Attachment 3
Ventura Steel Site Response

VENTURA COMPRESSOR STATION MODERNIZATION PROJECT

SOCALGAS

(Data Request 001)

Exhibit 3-23: Northeast-facing view of the existing Ventura Steel Site

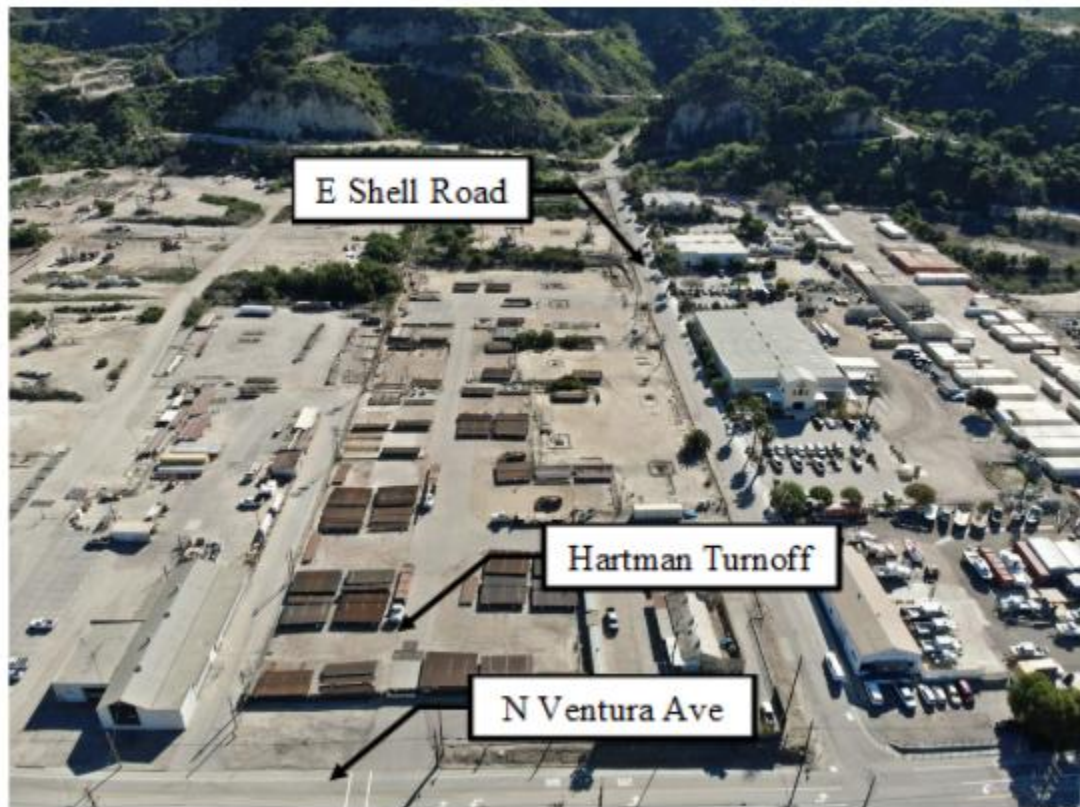
The following aerial pictures were taken by SoCalGas in March 2022 for the purposes of the Feasibility Study that was requested by the CPUC in August 2021.
